# Access Compliance Report

## Public Rights-of-Way (Curb Ramps)

| Intersection ID: N/A                    | Main Street: PAISLEY_ABBEY_LN | Cross Street: KELBURN_LN                | Location: NW           |
| ADA ID: 5C7E3F2AF0F2                    | Ramp Type: BlendTrans1        | Initial Pass/Fail: Fail                 | Overall Compliance: No |

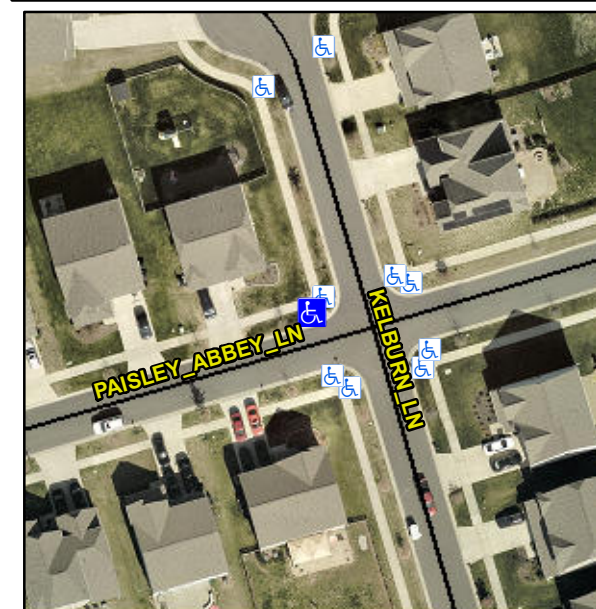
**R304.5.1, R304.5.3**

| Compliance | Description           | Data  | Compliance | Description                 | Data |
|------------|-----------------------|-------|------------|-----------------------------|------|
| No         | Ramp Width (in)       | 47.0  | No         | BlendTrans XSlope (%)       | 5.3  |

**Remove & Replace Curb Ramp With Two New Directional Ramps or Equivalent.**
